RE: Parker Ridge Phase 1B-Section 2 (FSP-25-16)
Major Subdivision Final Plat – Submittal #2

The enclosed plat was revised according to 1st review comments received on July 3, 2025. Please find the following responses to the comments provided on the Town's website.

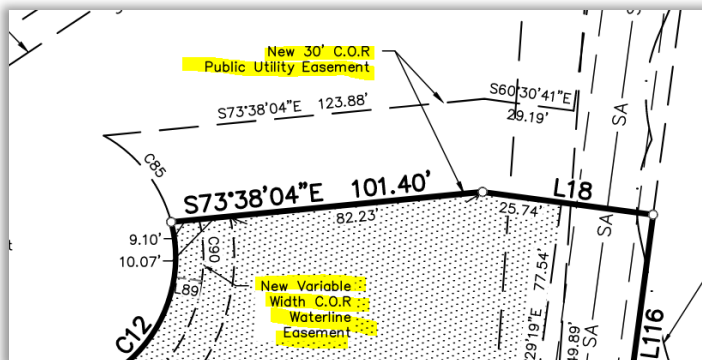
Comment #1: What plat is recording the Water and Sewer Easements?

Response #1: This plat describes only one (1) City of Raleigh Easement. It is a "New 3' C.O.R. Public Utility Easement" adjacent to the right-of-way of Granite Knoll Court. Parker Ridge – Phase 1B – Section 1 (FSP-24-24) records the water and sewer easements adjacent to this plat.
